RE: Indian Point Unit No. 3
Docket No. 50-286
REGULATORY DOCKET FILE COPY

REQUEST FOR ADDITIONAL INFORMATION

STRUCTURAL INTEGRITY TEST
INDIAN POINT UNIT NO. 3

FIG. 2.1

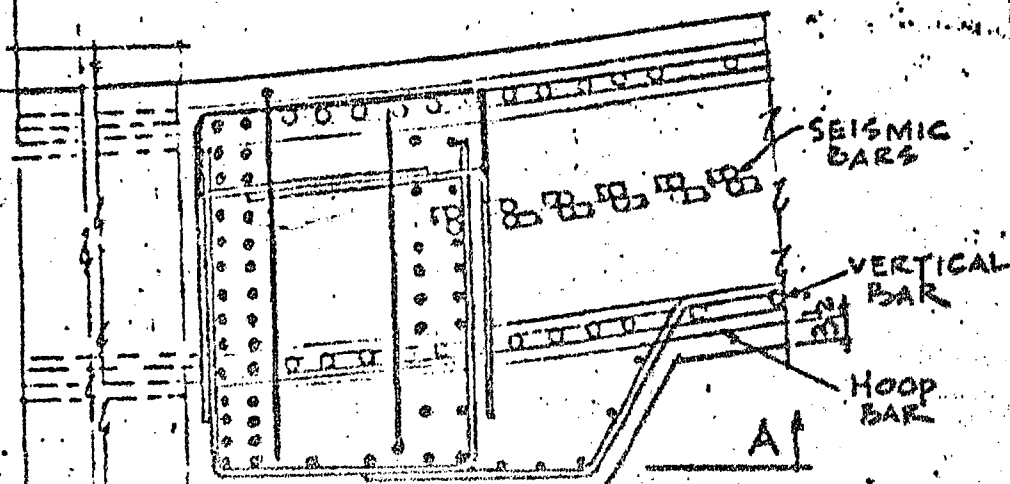
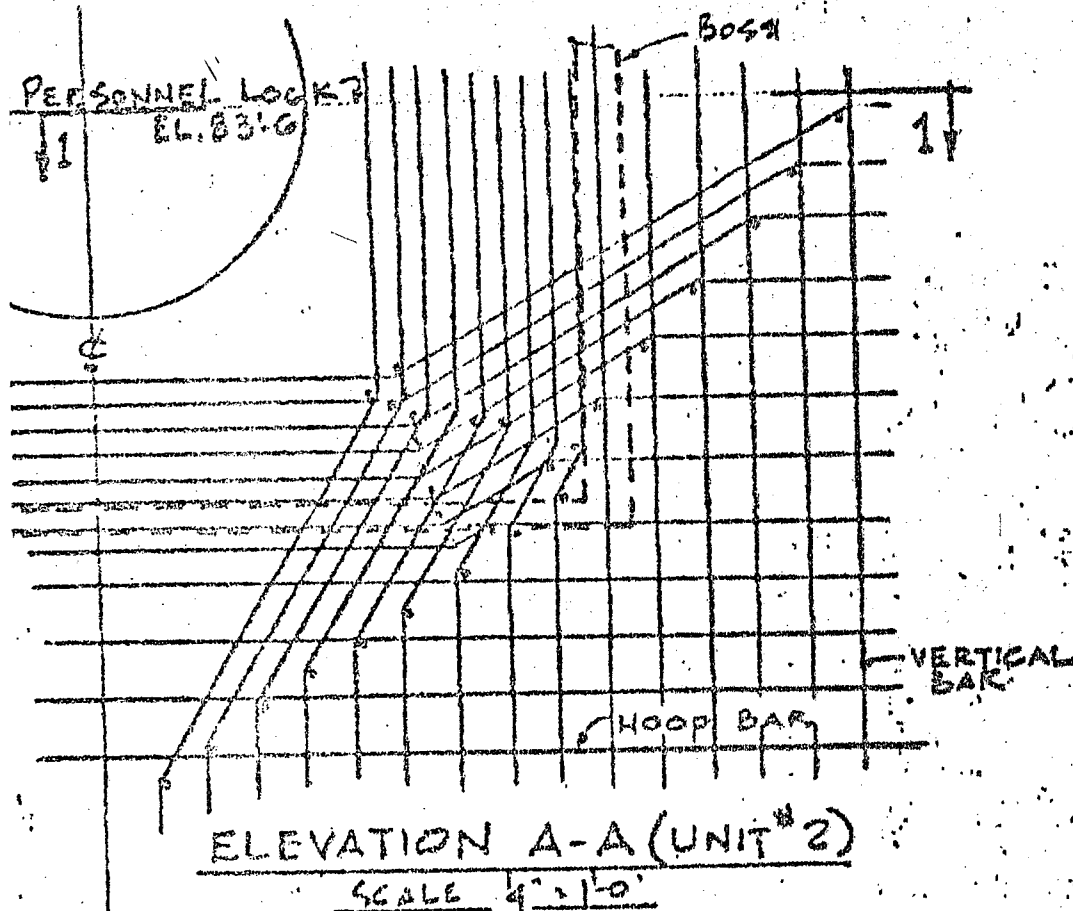
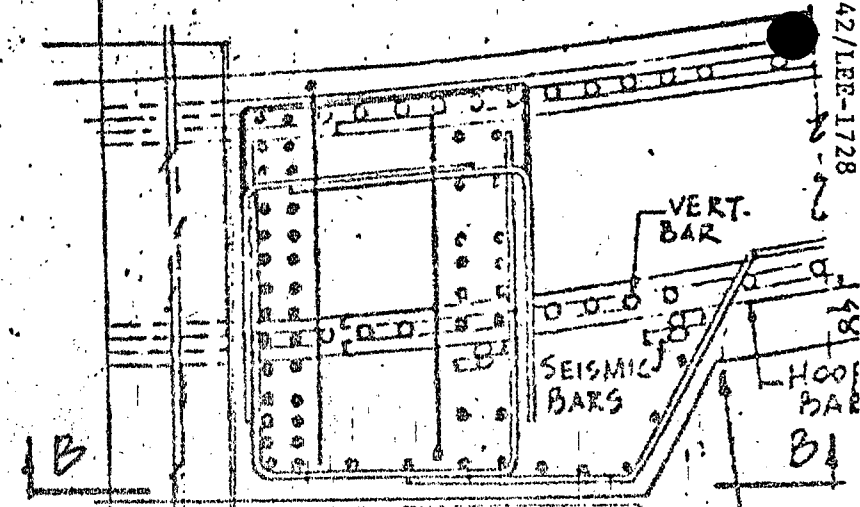
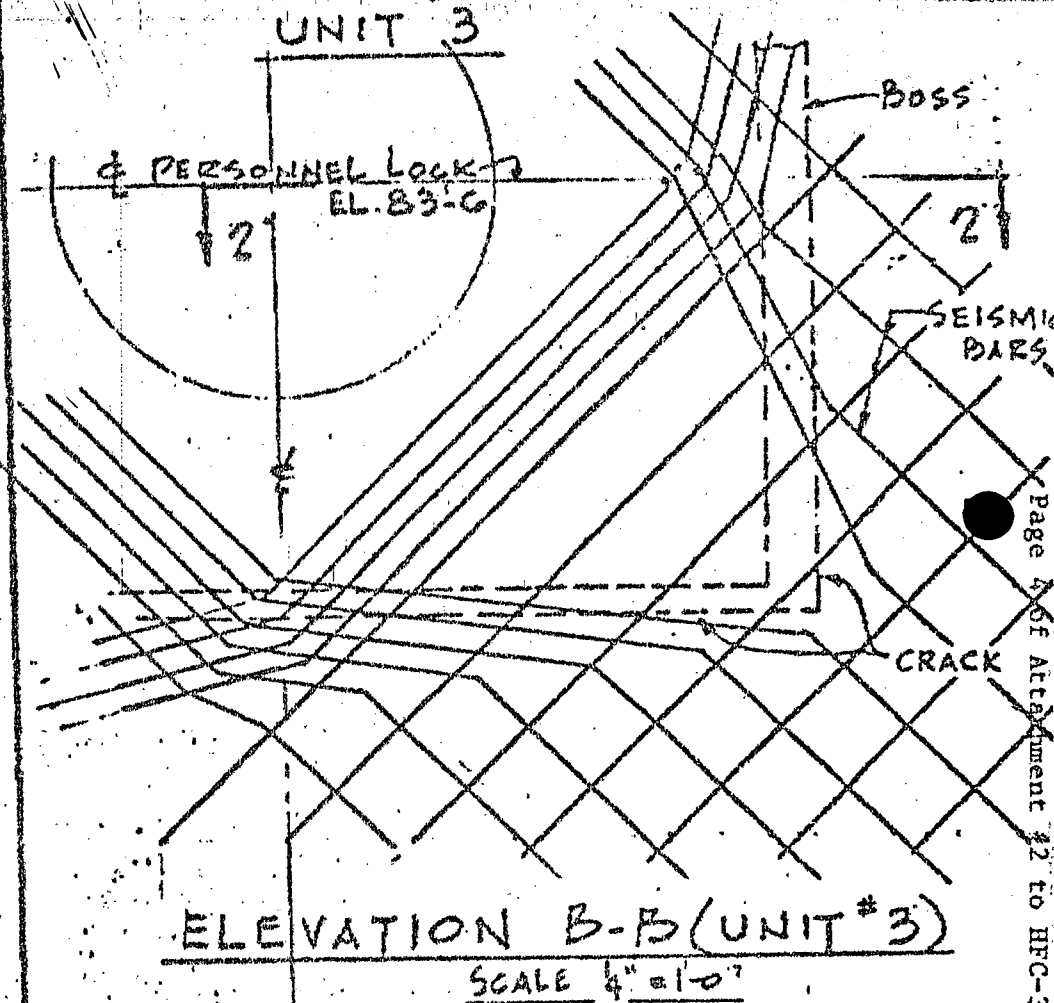
- c. Your explanation of the magnitude of the subject crack requires further clarification. Discuss the difference in location of rebars in containment for Units No. 2 and No. 3 and its effect on the crack width in a comparative form. Provide a more rational explanation of the differences than that given under item e) of Section IX and demonstrate that the excessive cracking will not impair the structural integrity of the containment.

The difference in rebar placement between Unit #2 and Unit #3 can be seen in the attached Fig. 2.1. For Unit #3 the outermost rebar is the seismic rebar. As shown in Figure 8 under Tab IX a large void is created when the seismic rebar bends around the opening. Figure 8 is the design drawing. It can be seen that a slight shift in seismic rebar location could cause a large void in seismic rebar at the lower left corner where the largest cracks occurred (see Figure 2.1). The first layer of rebar crossing the crack is thus the diagonal rebar in the orthogonal direction to the layer with the void in the crack area as shown in Figure 2.1 for Unit #3. Due to the 30" spacing of the rebar only one bar can potentially cross the crack area. In addition the horizontal rebars, which are most effective for vertical crack control are 8½" from the surface for Unit #3, since they are pushed further into the section by outside seismic rebar. For Unit #2, where the outside layer of rebar is the horizontal rebar which crosses the potential crack, the concrete cover is 3½". The differences in concrete cover between

Units #2 and #3 in Figure 2.1 comparatively illustrate the differences in rebar placement between Units #2 and #3 and provide an explanation why greater concrete cracking could be expected for Unit #3.

As stated in Item c) of Section IX the primary loads are carried by the rebar in this area; therefore the existence of concrete cracking is not a problem by itself. The concrete cracking is monitored during the test as an indicator of where rebar stresses may be high. Based on the many reasons why cracking is expected in this area as detailed in Section IX and the observation in Item f) of Section IX that the crack closed properly as pressure was reduced, the concrete cracking in this case does not indicate the presence of unacceptable rebar stresses.
